34-H-1

58 Alder Street

Bayside Bowl Expansion

#2015-049

Proposed Bayside Bowl Site Plan

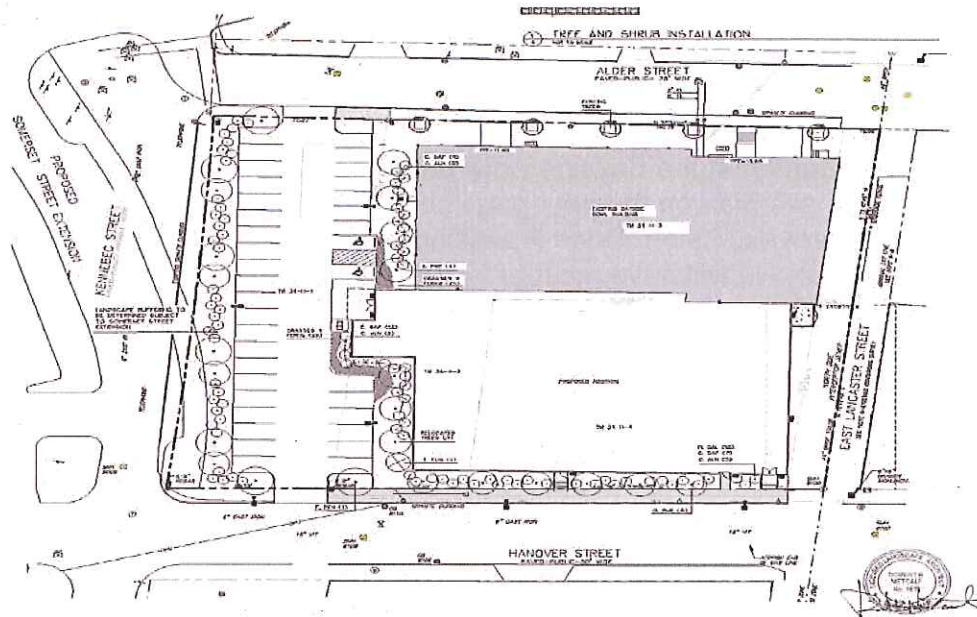
Parking includes a temporary 36 space lot on-site (gravel surface) and 17 shared spaces off-site. The temporary parking lot would have formal review at a later date once the B-7 zoning parking lot issue for this site has been resolved and the alignment of Somerset Street extension has been finalized. See next section (Surface Parking Setback under B-7 Zoning). The 7 existing spaces on the Hanover Street side of the property are eliminated to accommodate the building addition footprint.

An 8 foot wide brick sidewalk is proposed along Hanover Street while the existing brick sidewalk along Alder Street is being extended about 22 feet but both sidewalks stop at the parking lot driveway in deference to the future alignment of Somerset Street which will likely be constructed in 2016. The proposed alignment is shown on the plan below. We would suggest that when the parking lot comes in for formal review in the future that the applicant be responsible for extending the sidewalk to meet the new sidewalk along Somerset Street.

A landscaped area is shown between the parking lot and the building addition (Kennebec side) but no walkway is shown on the plan. We are recommending that a sidewalk be installed within this area connecting to the public sidewalks on
